AMERICAN PETROLEUM INSTITUTE

July 16, 2015

Re: *Blowout Preventer Systems and Well Control, 1014-AA11*

ATTACHMENT F

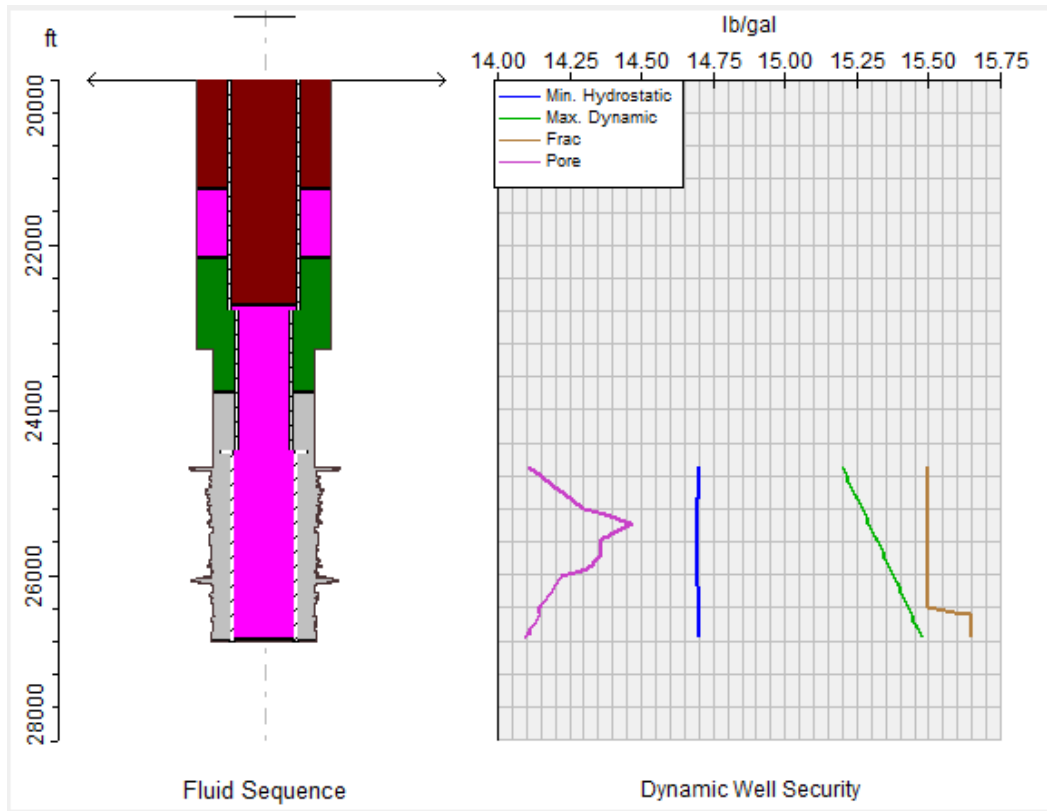
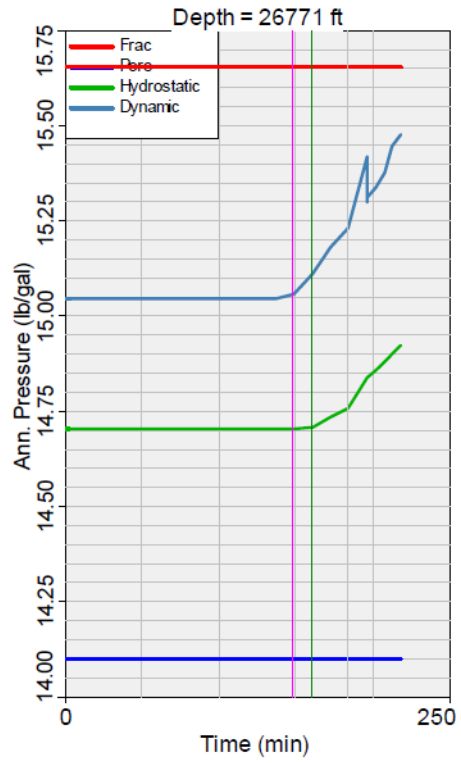
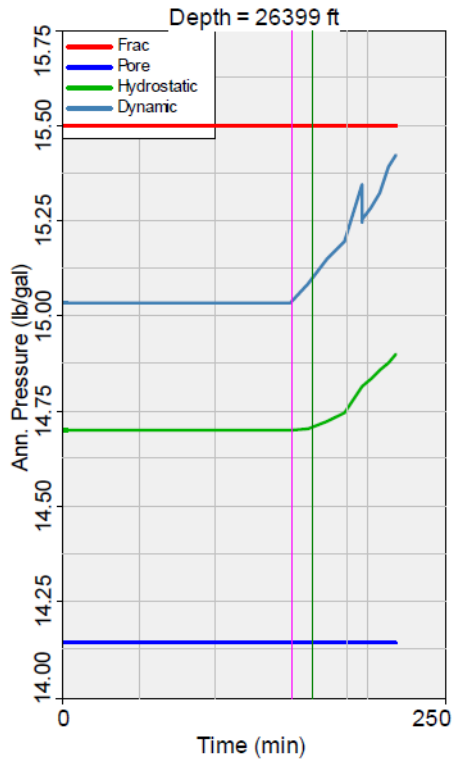
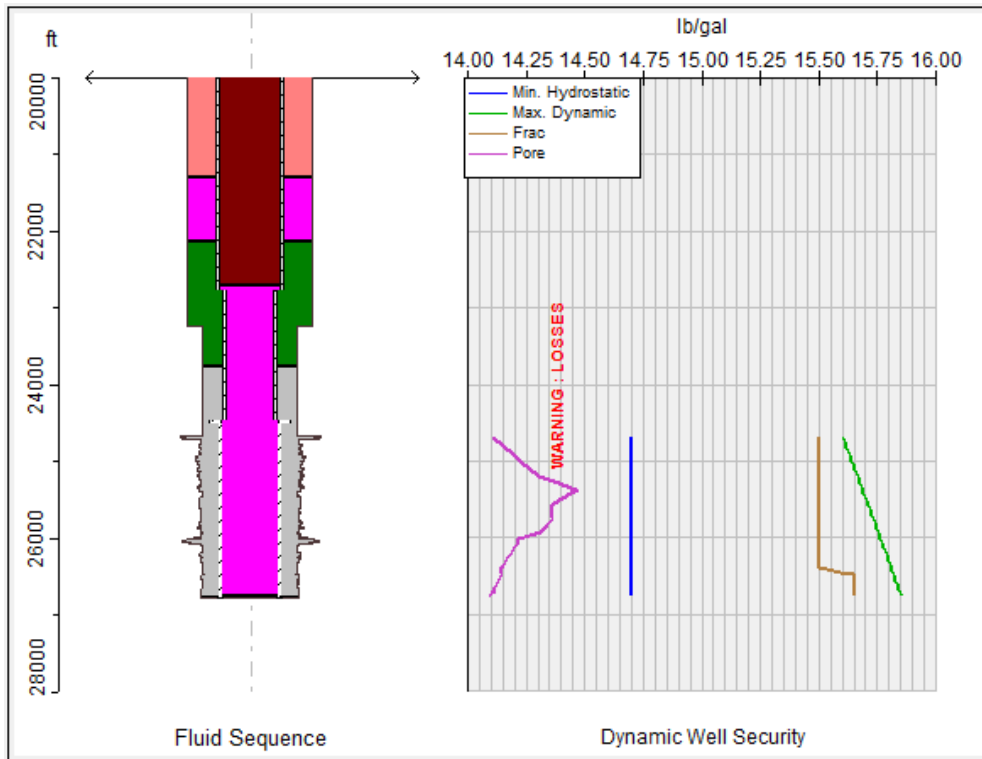
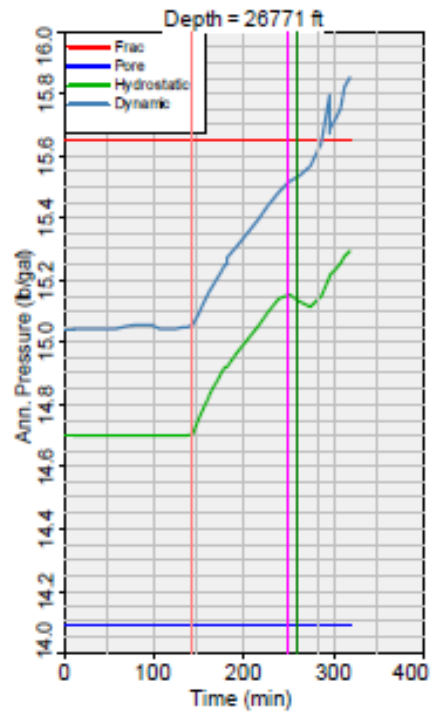
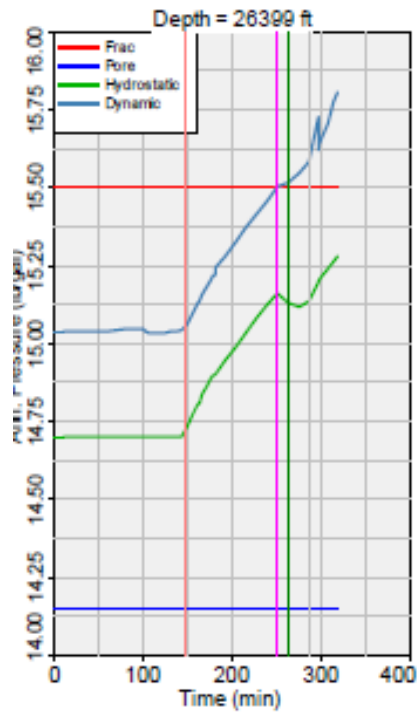
In response to the proposed CFR 250.420(c)(2) well control rule, the below comparison simulations were run on a typical deep-water development well production liner cement job that was successfully performed in 2013 to isolate multiple HC zones in the annulus without any losses (see below “BASE DESIGN – CASE A”). In order to accommodate the new code as stated in CRF250.420(c)(2), a “REVISED DESIGN – CASE B” is also presented below which incorporates a weighted fluid ahead of the cement to offset the hydrostatic pressure loss during the cement setting process – assuming the cement goes from a 16.3ppg density to 8.34ppg density. Incorporating this weighted fluid ahead of the cementing fluid train during placement significantly enhances the potential for losses and subsequent inability to isolate the HC zones in the annulus.

REVISED DESIGN – incorporating 300bbl 16.4ppg slug to restore BASE CASE overbalance pressure assuming cement column density to 8.34ppg

# Example #1 – 1450' Water Depth (Current Design)

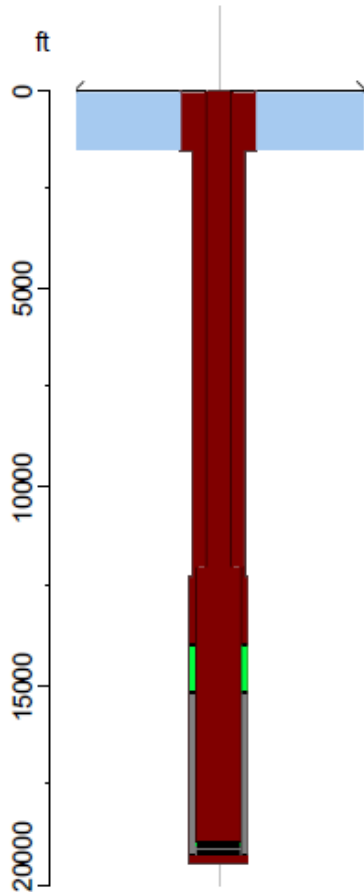
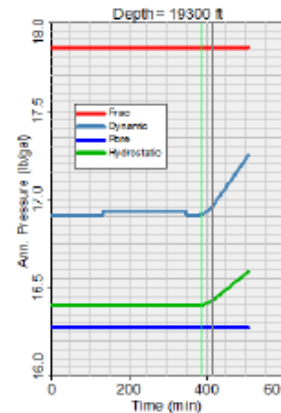
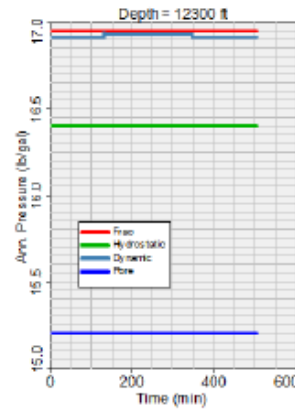
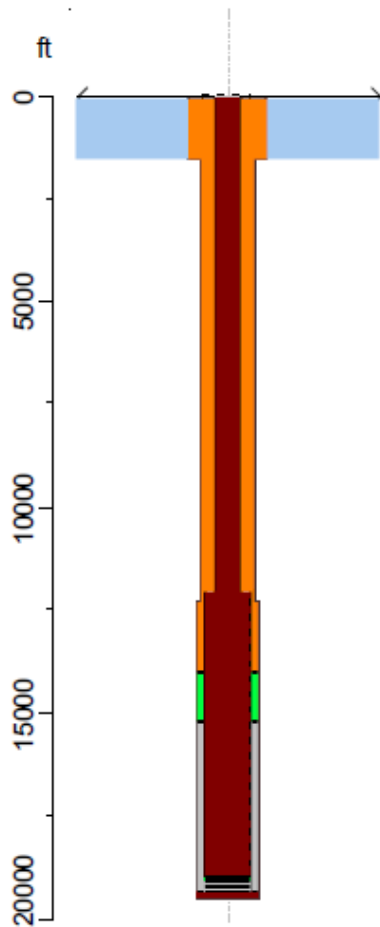
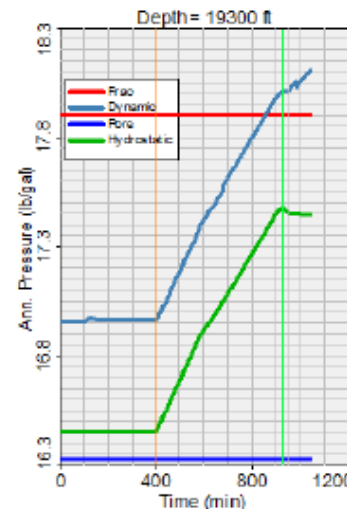
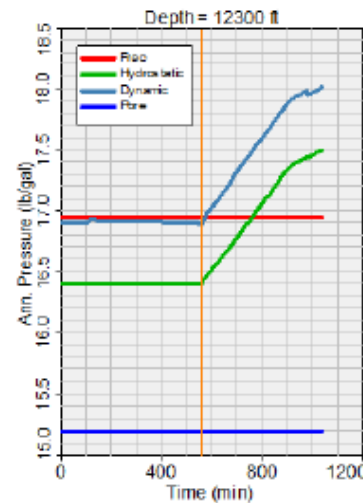
Hydrostatic balance point at the TOS. The salt is assumed benign and not able to flow in this example.

Hydrostatic balance (14537 psi) can not be achieved with 17.5 ppg mud back to surface.

# Example #2 – Shelf (Current Design)

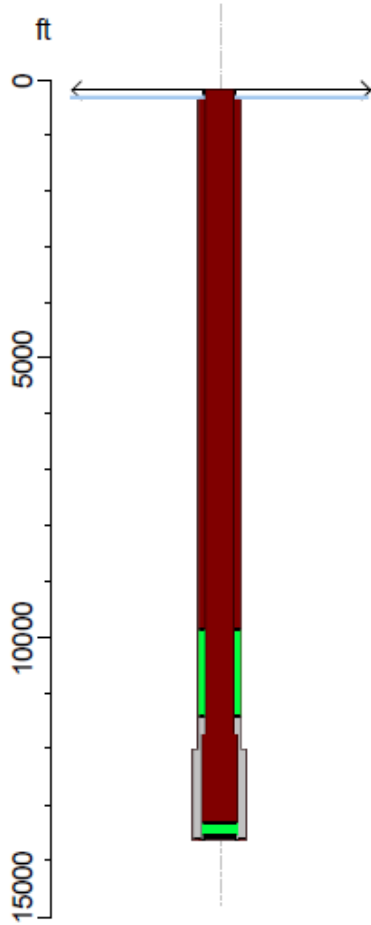
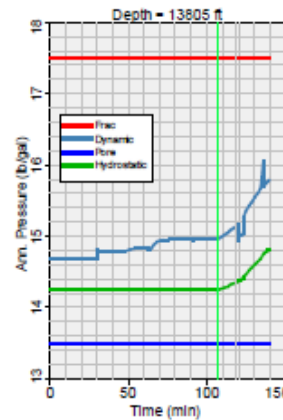
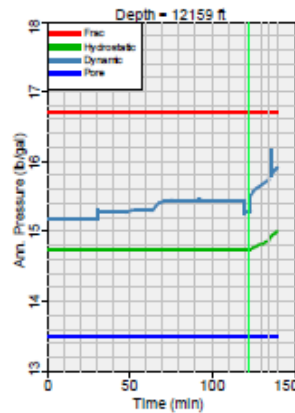
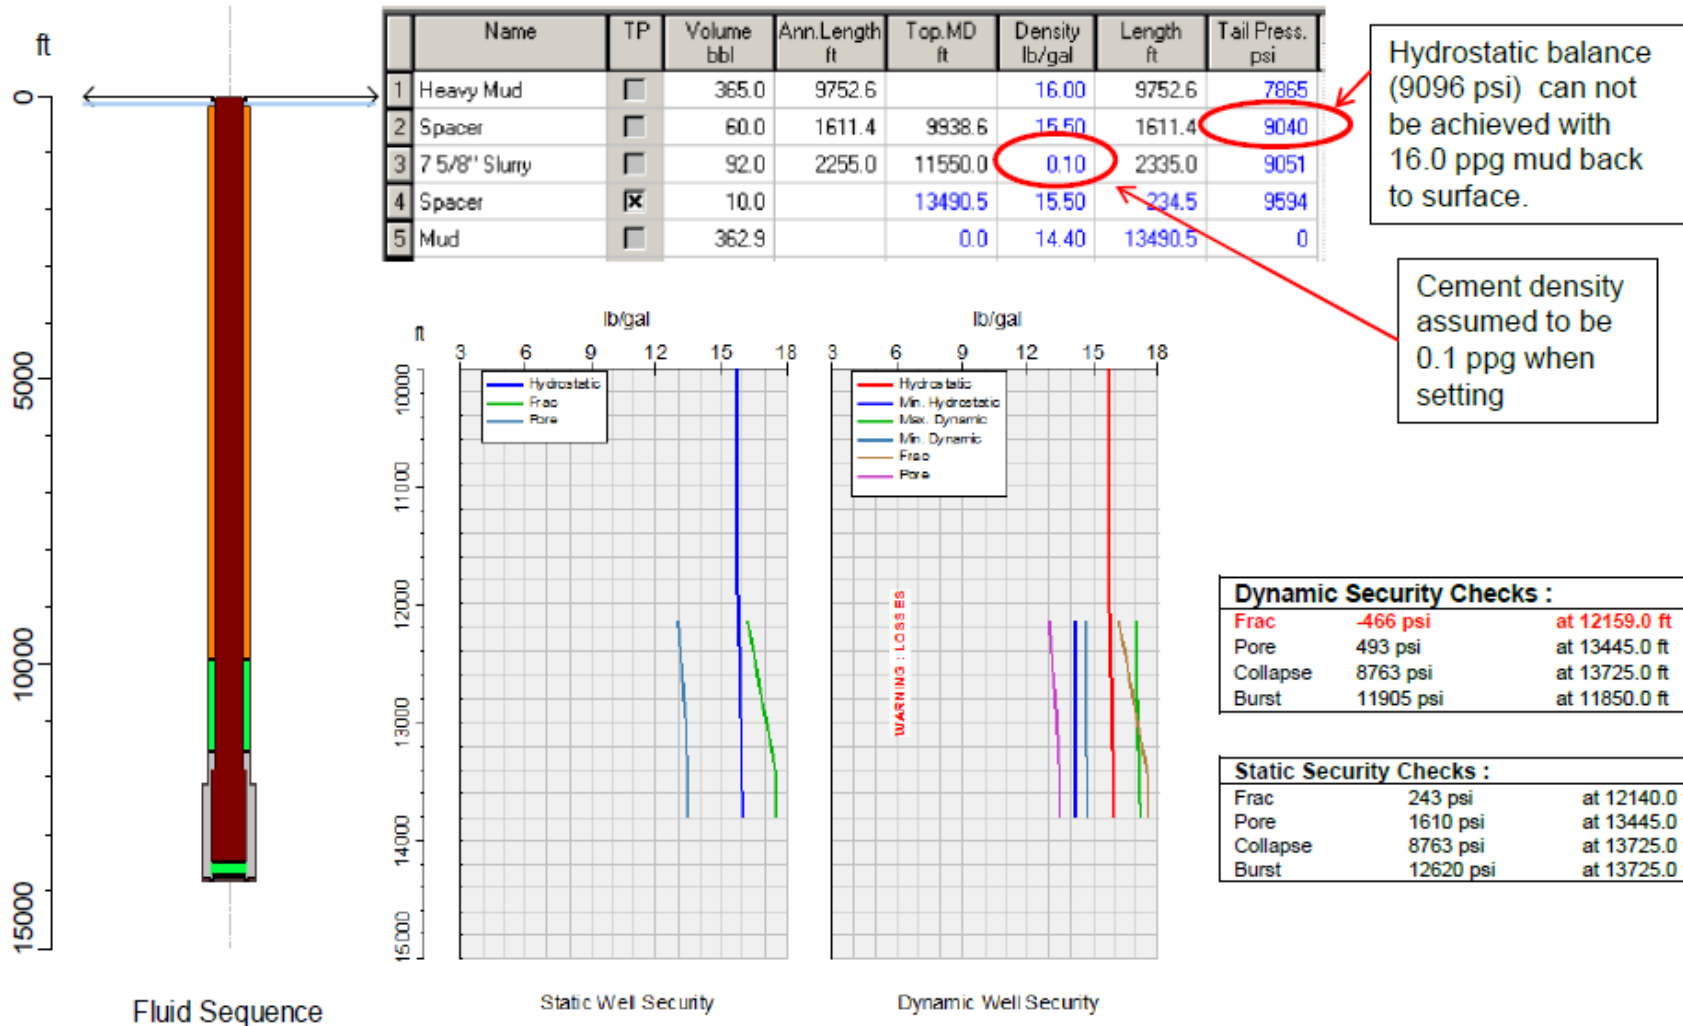
Hydrostatic balance point at the base of the potential flow zone.
